SAFETY EVALUATION BY THE OFFICE OF NUCLEAR REACTOR REGULATION

SUPPORTING AMENDMENT NO. 27 TO FACILITY OPERATING

MONTICELLO NUCLEAR GENERATING PLANT

DOCKET NO. 50-263

Figure 1 RHR Intertie Modification

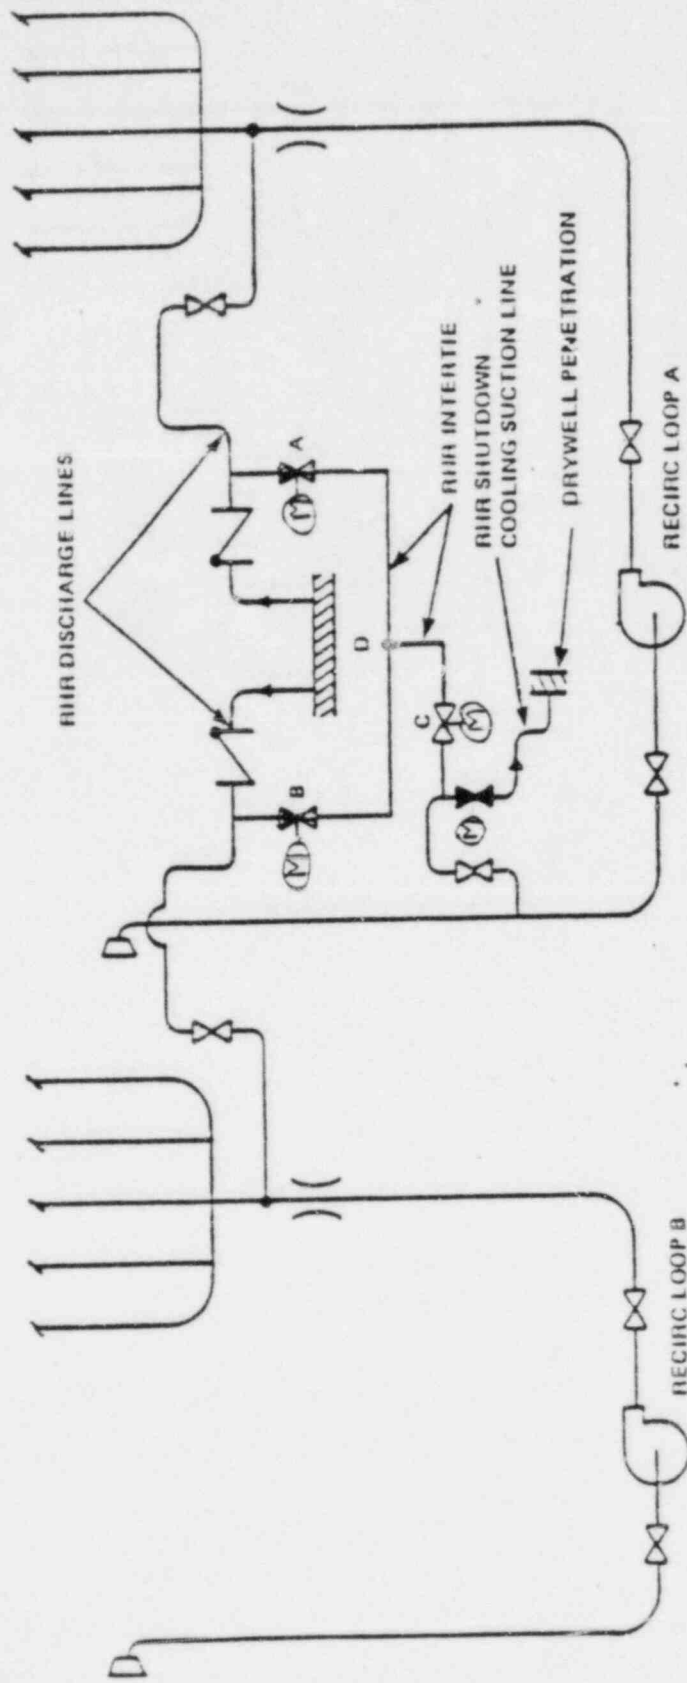
The new intertie line would be normally isolated during plant operation with MO-4085A and MO-4085B closed and MO-4086 open. The line would be used:

2. To prevent a recirculation loop waterhammer in a hot isolated loop during primary system depressurization. In this case, MO-4985A and MO-4085B would be opened and MO-4086 would be either open or closed, depending on which loop is isolated.

Since the intertie valves are assumed to be open at the time of a postulated accident, the effect of the intertie on the DBA break size was evaluated. NRC-approved evaluation models were used in the analysis. Assumptions and models used in the latest Monticello LOCA analysis (Ref. 1) were also used in the new analysis.

The intertie is a four-inch line with a flow area of 0.08 ft<sup>2</sup>. If this flow area is added to the former maximum flow area, the new 100% DBA break size becomes 4.09 ft<sup>2</sup>. The addition of the intertie flow area increases the maximum flow area by about 2%. The analysis performed for the new maximum flow area indicates that the difference in the time of core uncover is less than one second. There is no change in the limiting break size (1.36 ft<sup>2</sup>) with or without the intertie. There is no significant impact on the Appendix K analysis.

The licensee's analysis indicates that the effects of the increased DBA break size of 4.09 ft<sup>2</sup> on the peak containment pressure and temperature are slight increases of 0.9 psig and 1°F, respectively. The licensee's analysis also showed that the pool swell loads on the torus shell and internals would increase by less than 1% due to the increase in the drywell pressure.

Technical Specifications prohibit the use of intertie line with the reactor in the run mode. Therefore, since the flow-biased scram and rod blocks are not required to be operable in shutdown mode, there is no need to adjust the flow-biased scram and rod blocks.

The following Limiting Conditions and Surveillance Requirements are proposed for additions to the Technical Specifications:

1. Quarterly cycling of MO-4085A, MO-4085B and MO-4086. In addition, these valves will be included in the Monticello ASME Code, Section XI, Pump and Valve Testing Program.
2. Requirement for operability of MO-4085A and MO-4085B at all times. In the event of an inoperable valve, actions are specified to assure full LPCI flow.

3. Limitations on use of the intertie line. Flow will not be allowed in the line if the reactor is in the run mode.

The limiting conditions and surveillance requirements proposed by the licensee are acceptable to the staff.
